citizenM Hotel
201 Westlake Ave N

SDCI Project # 3023379

Design Review Board
West Design Review Board

Date: April 26, 2017

Massing & Relationship to Context

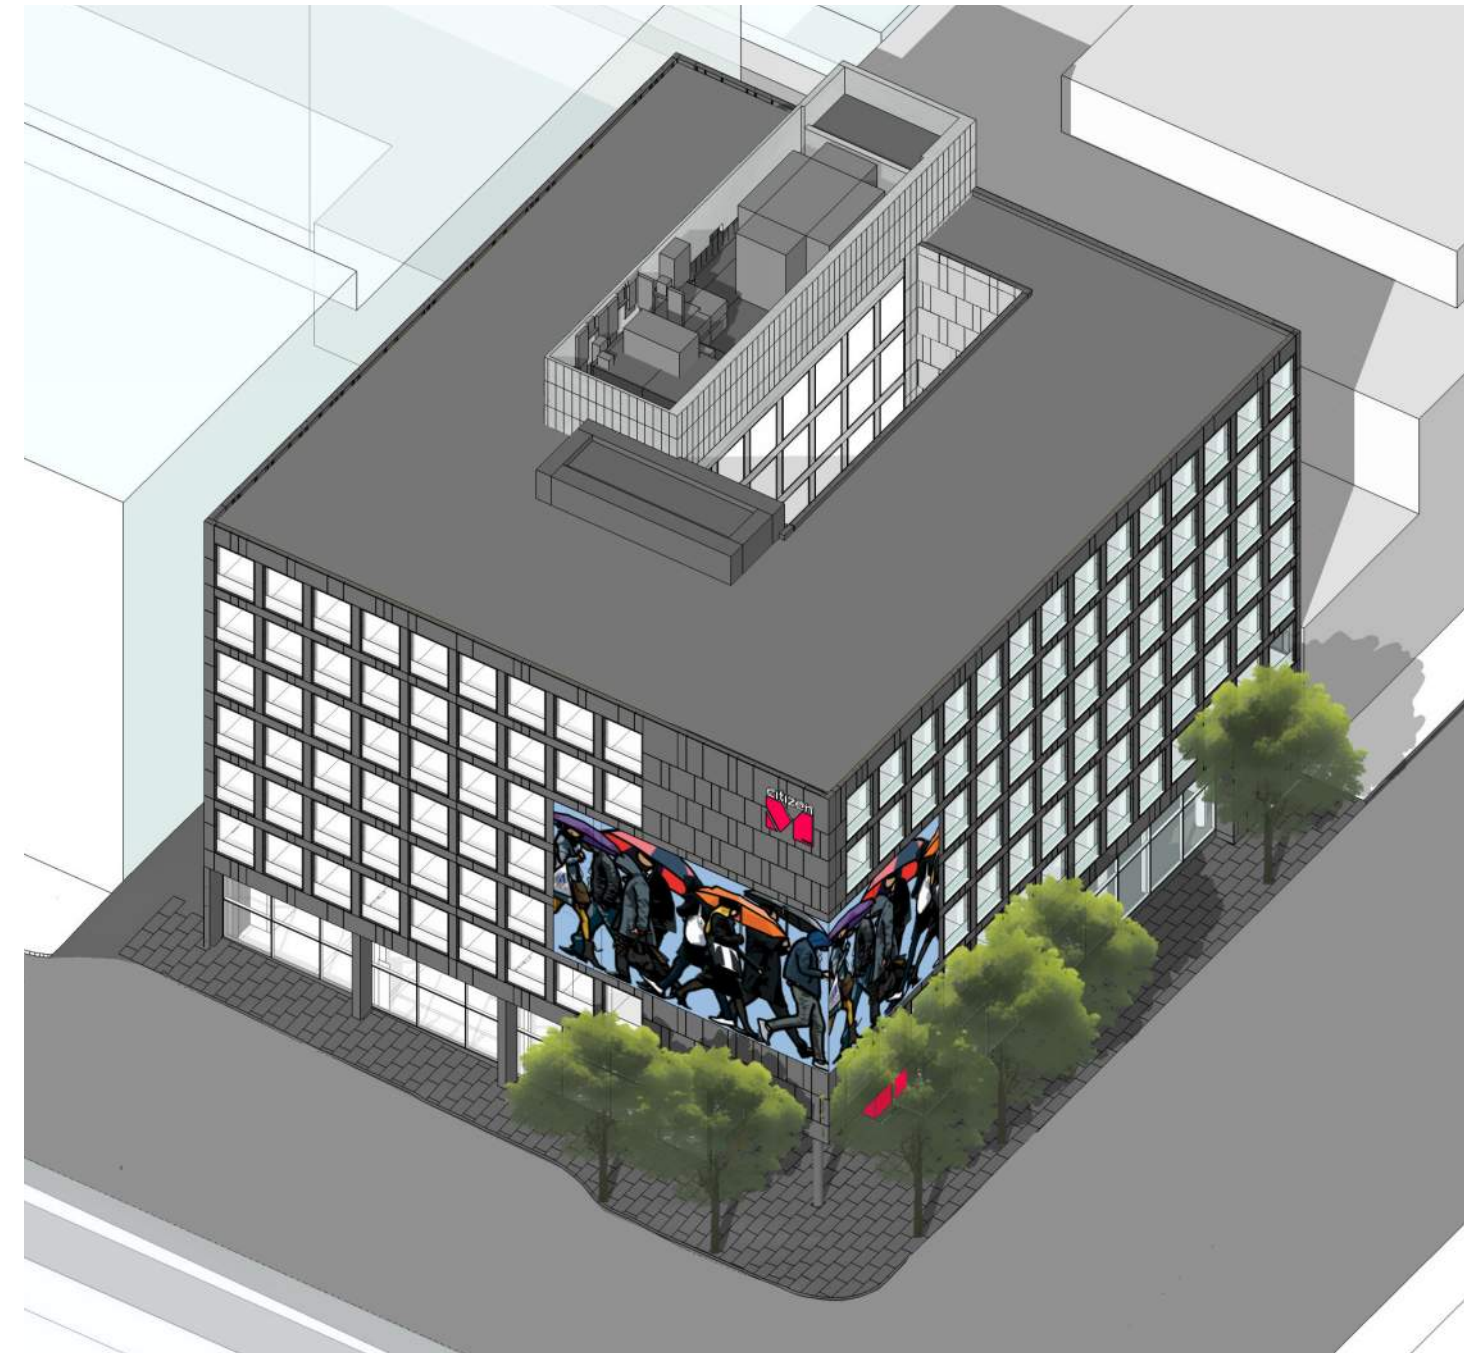
“...recognized the proposed modular construction as unique...”

“...strongly supported Scheme Three, as the courtyard location best responds to the context and the massing addresses the different streetscape conditions and minimizes blank walls....”

- From Westlake and John, the proposed massing will be substantially similar to the approved EDG massing;
- At the upper levels, the proposed building continues to respect the street wall along Westlake and John. At street-level, the glazed connection between sidewalk and the interiors has been strengthened

- From the north, the courtyard has been enclosed in order to address substantial seismic forces acting on a U-shaped building. The design team is proposing a simple, yet well-detailed treatment to the north elevation. The impact of the building's shadows on the adjacent properties has been studied as well.

Architectural Concept & Frontages

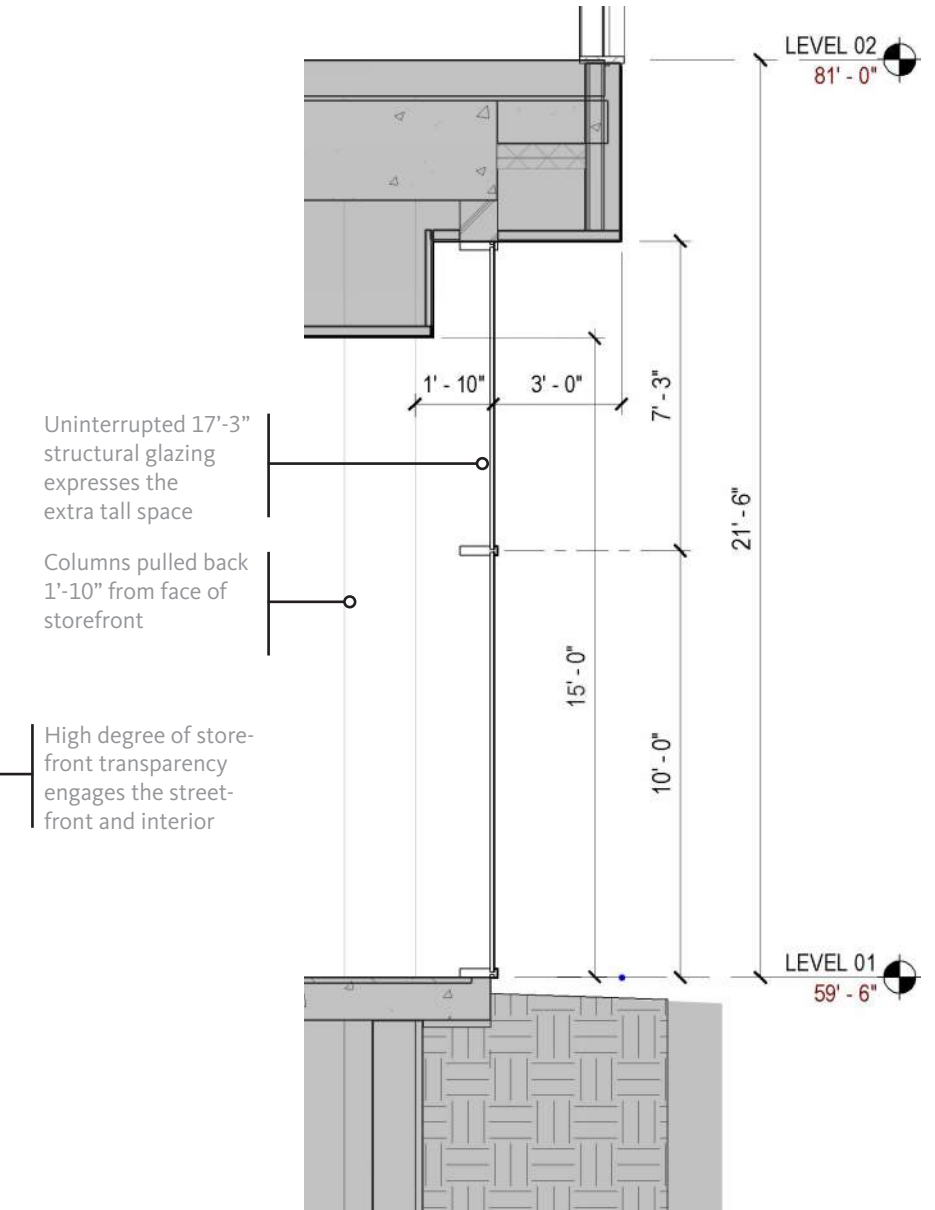
“...supported the 2-story structural glazing and the design concept of integrating the inside and outside activities ...”

keep “the storefront as clean as possible...”

“...the columns should be set back, disengaged with the storefront system to allow for the maximum transparency...”

- Tall glazing allows direct views between the sidewalk and the public spaces of the interior
- Corner entry provides exterior public space and facilitates way-finding
- Columns are disengaged from the curtain wall system allowing a clean uninterrupted plane of glass

- The hotel's public areas have been condensed into one, tall floor at street-level.
- 17'-3" tall glazing is proposed along Westlake and John street fronts. Finished ceiling heights of 15'-0" will create a direct, significant connection between the pedestrian realm and the public areas of the hotel. Previously, the street front glazing was proposed to be 25'-0"; finished ceilings were to be 10'-2" to 11'-8". The volume of space directly connected to the life of the sidewalk is significantly greater

APPROVED EDG: BUILDING SECTION: E-W COURTYARD LOOKING SOUTH

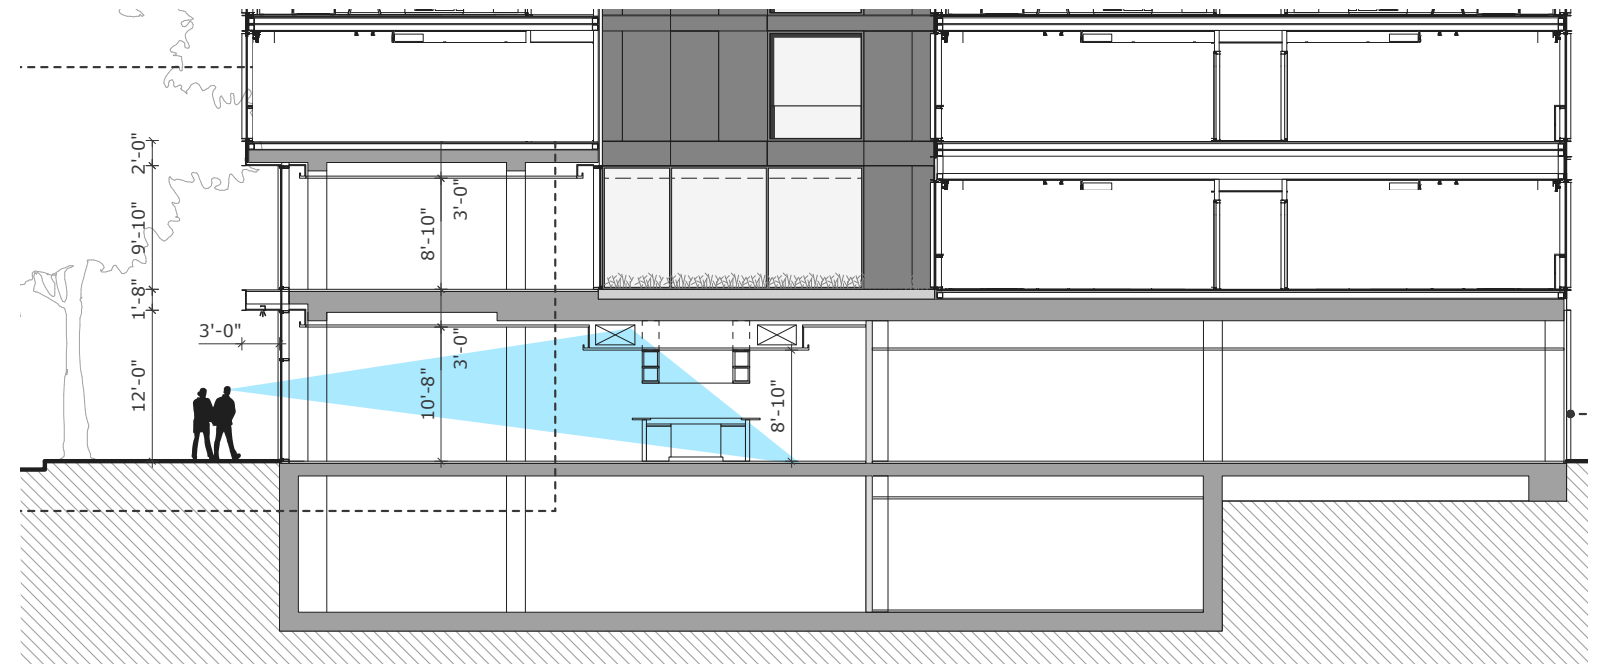
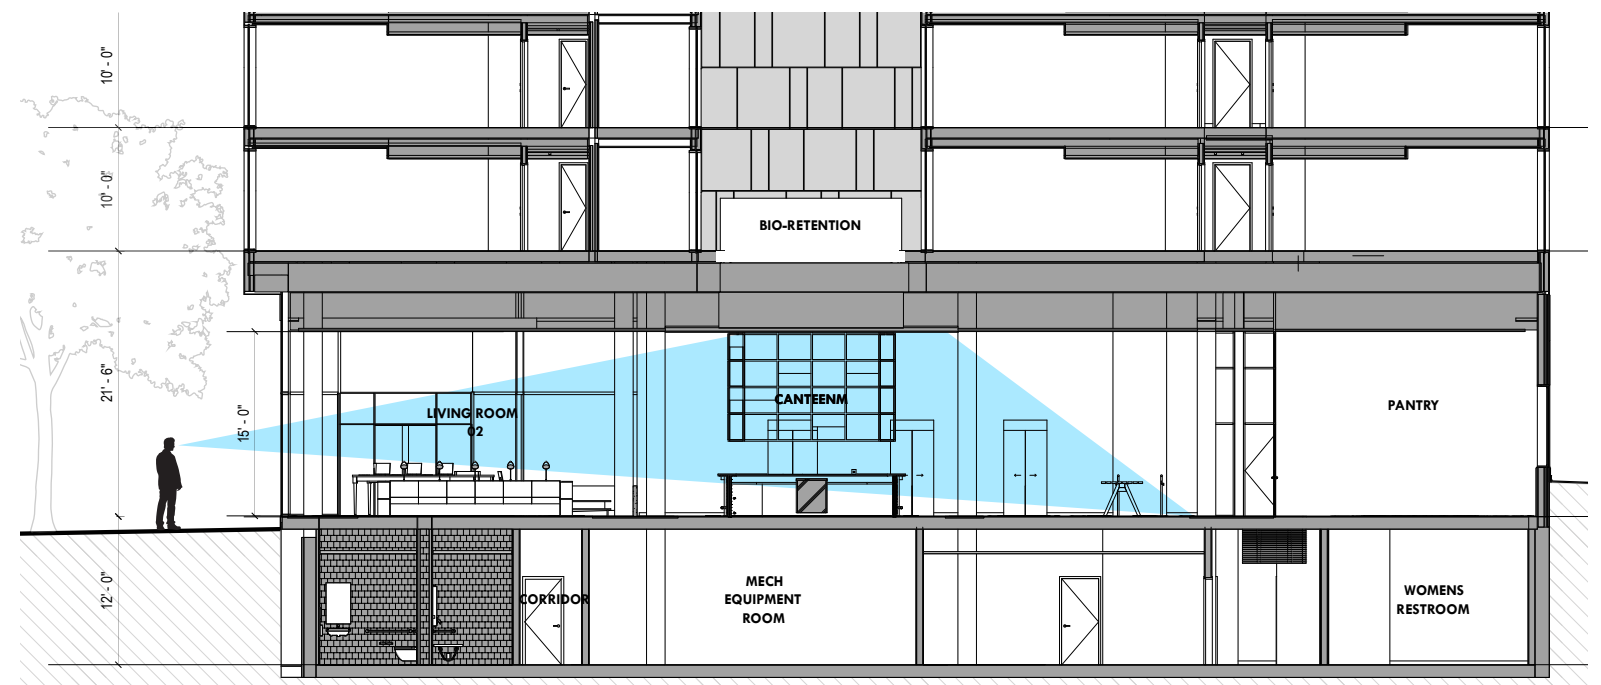
"...requested studying if the courtyard space will be visible to the pedestrian through the 2-story structural glazing..."

"...encourage more transparency to allow for views of daylight coming from the courtyard space...."

- As part of the development of the scheme presented at the EDG, the design team studied the visibility of the courtyard from the sidewalk. Because of the significant canopy of the existing trees, direct sight lines between the sidewalk and the courtyard would not have been possible.

- With the single floor of public areas, 15' clear ceiling heights are proposed.

Architectural Concept & Frontages

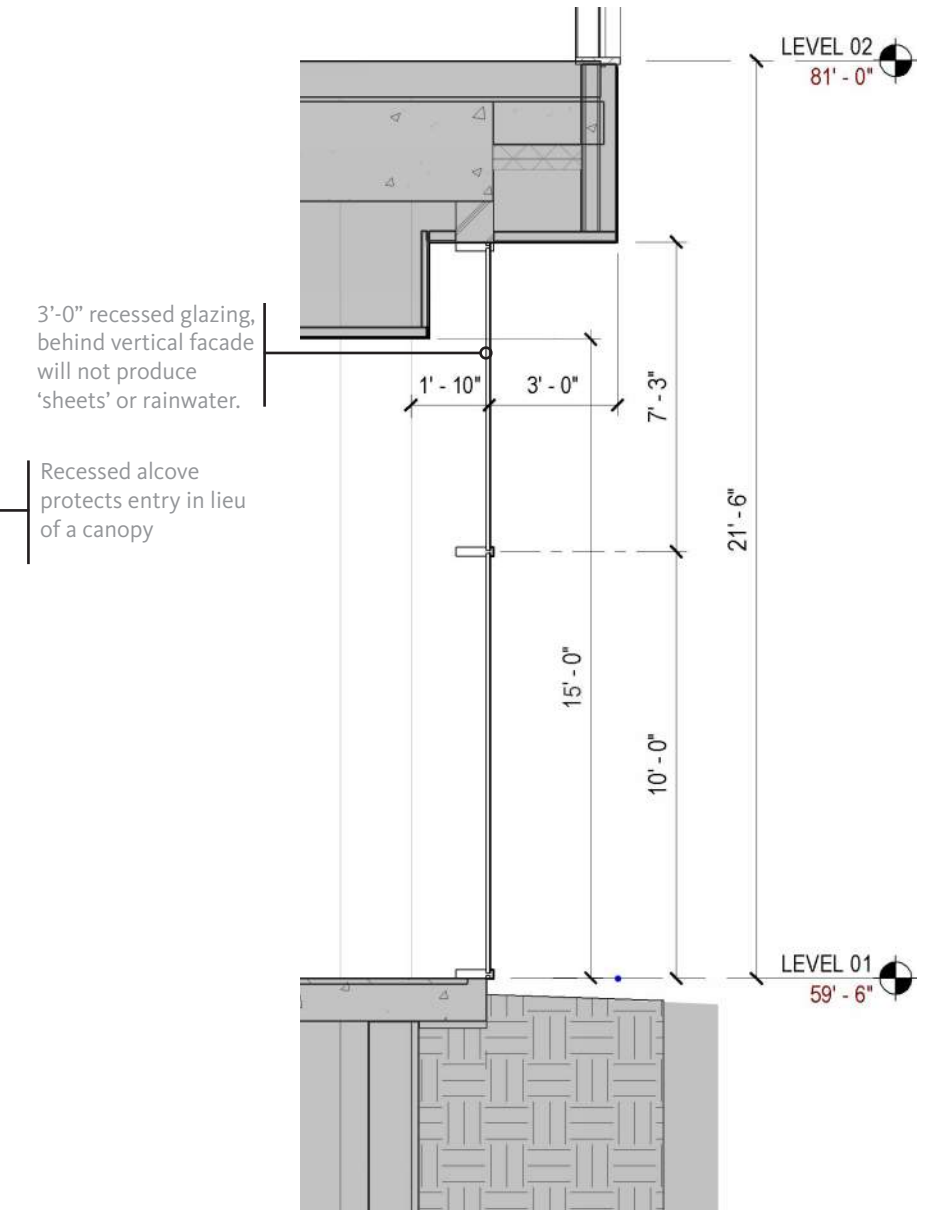
“...supported the lack of overhead canopy as it avoids bifurcating the 2-story glazing...”

“...recommended developing a concealed, integrated gutter system...”

- The tall volume of the street level is expressed at the glazed facade with no interruptions. The glazing remains recessed from the street front by 3’;
- The design team in conjunction with the engineering team and facade consultant, investigated the impacts of a gutter system at the base of the guestroom volume. The net amount of rain that would collect on the vertical surface of the facade is small. This is due to the relative lack of high wind or high volume rain events in the Seattle area.

- Canopies are typically employed to ensure that a larger horizontal walking surface remains protected from rainwater. The effect of rainwater on a non-guttered facade is a sporadic linear drip
- Rainwater collection on a typical 8’ wide canopy along the street-front of this project would yield the following annual water collection:

AREA	AVERAGE RAINFALL	CONVERSION FACTOR	
8’ x (120’ + 107’)	x 36.15”	x 0.623	= 40,899 GA/YR

This is equivalent to 4.69 GA/HR along the entire street front

- Plumbing engineers have observed that sheets of rainwater cascading down vertical surfaces are highly uncommon phenomena, mainly due to the fact that the wind vortex on the shear face of a facade tends to blow rain away from the building
- Sheets of rainwater can occur on buildings with sloping facades. It is the opinion of the engineers working on this project that no facade rainwater catchment system is necessary

Architectural Concept & Frontages

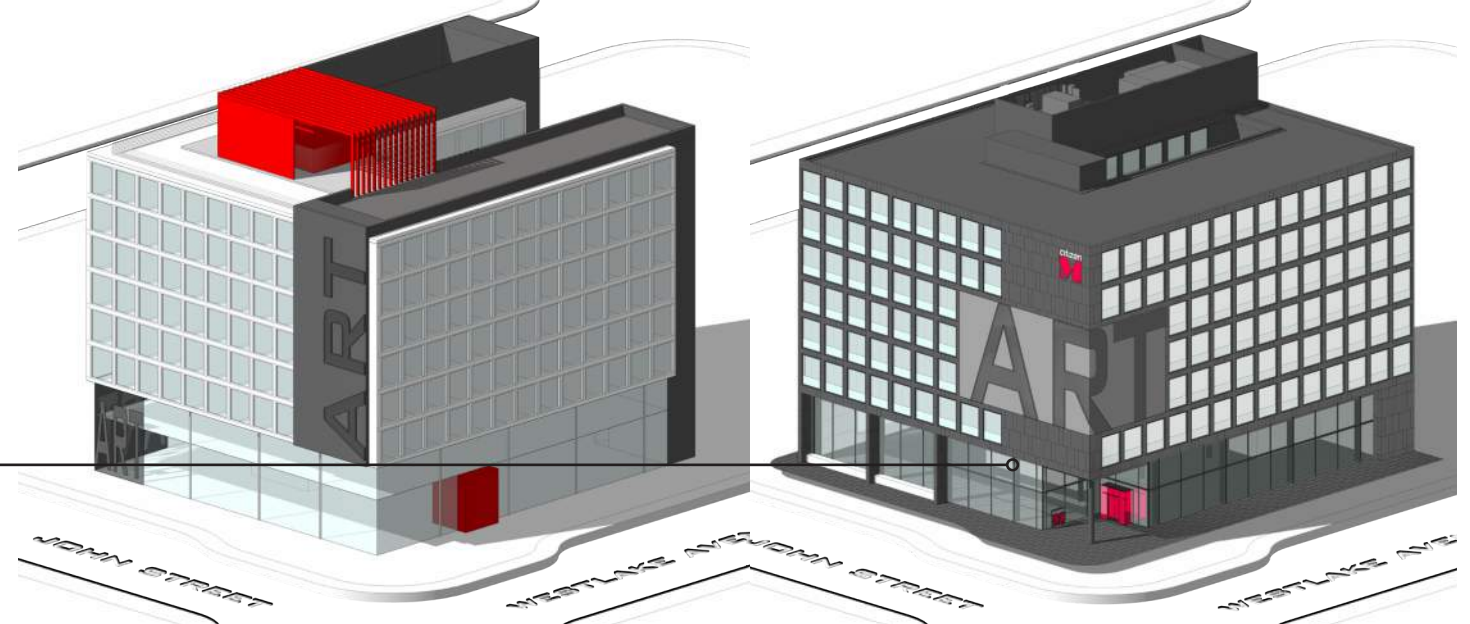
“...supported proposed art along John and recommended wrapping the art into the alley.”

“...noted that this corner can be pushed forward to mitigate the increased setback along Westlake and increase visibility from the nearby Denny Park.”

- The artwork at the corner of Westlake and John has been significantly increased in size and re-oriented horizontally to better address the corner and catch views from both Westlake and the increasingly important pedestrian green street.

- The artwork previously shown to wrap the southwest corner into the alley has been removed. As part of the building re-planning, the elevator core has been re-oriented (E-W direction) and brought closer to John St. The entirety of the core at the ground-level will be faced with artwork. Due to the high degree of transparency along John St., this interior art work will be highly visible on the approach from Denny Park to the southwest
- Meeting room programming extends into and activates the length of the alley

Architectural Concept & Frontages

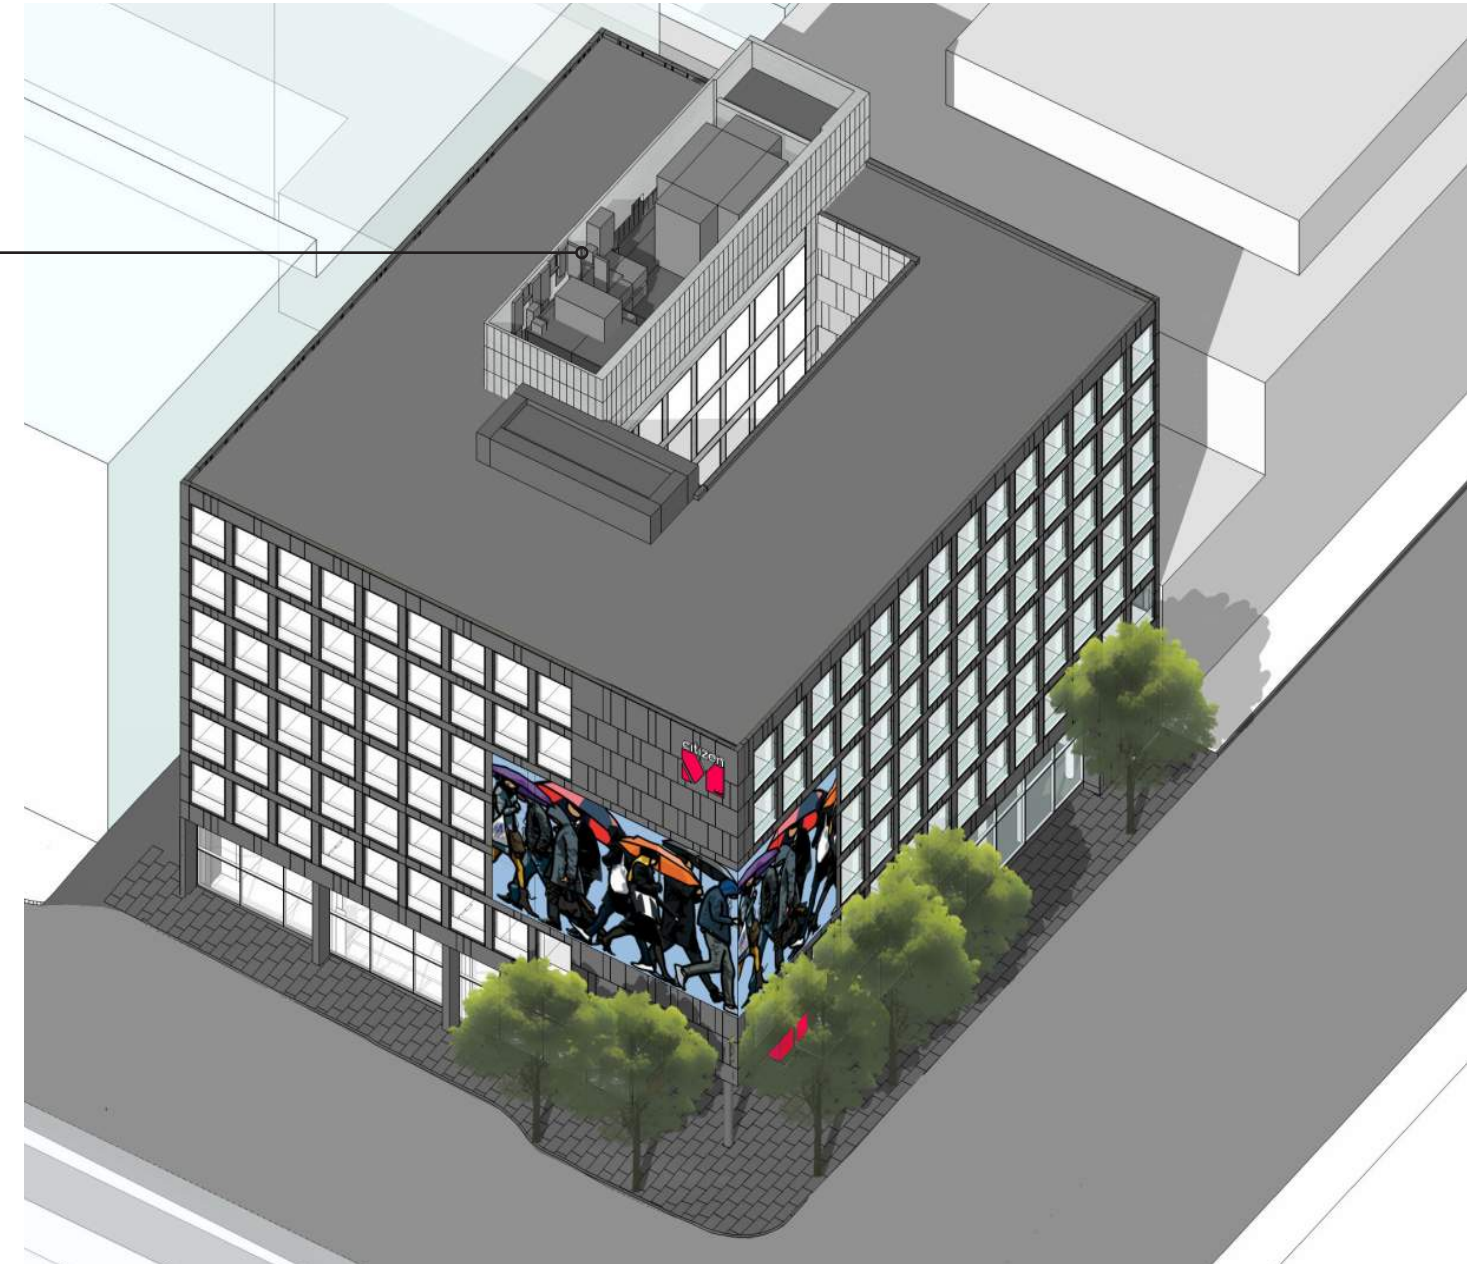
“...agreed the projecting rooftop feature clad in red color creates a sculptural composition...”

“...encourage vertical core expression to continue and connect down to the highly transparent base.”

- Mechanical penthouse reduced in size and moved further from street fronts. Departure for mechanical penthouse coverage no longer required
- Roof no longer occupiable; rooftop pavilion removed. Departure to allow rooftop pavilion no longer requested
- Elevators no longer serve roof. Elevator penthouse reduced significantly; no longer visible from the surrounding streets

Roof penthouse structure no longer visible from most of the surrounding streets
